TANK VENT CHANGE

Old style check valve

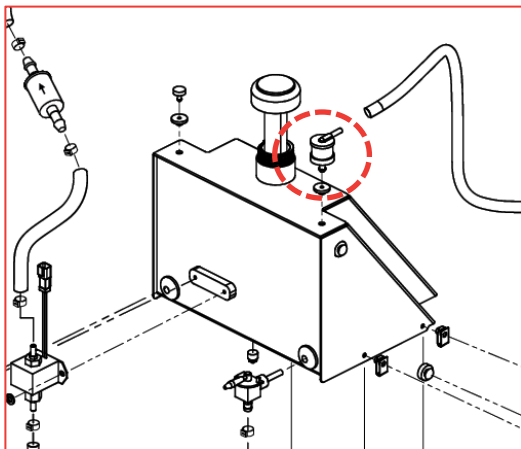
It has been noted in some cases the old check valve located on top of the fuel tank was not allowing proper venting and could lead to an over fueling condition of the carburetor and engine.

Replacing the check valve to a 90° elbow fitting is recommended to prevent unwanted tank pressure. In conjunction with the 90° elbow fitting, the grommet should also be replaced to maintain proper sealing.

- [MQ Part # 12007](#) – 90° Elbow fitting
- [MQ Part # 23507](#) – Rubber grommet

Production change beginning with serial numbers below will be equipped with the 90°elbow fitting.

- **Serial #RC0208767** for HHNG5.
- **Serial #RC0208806** for JWN24.
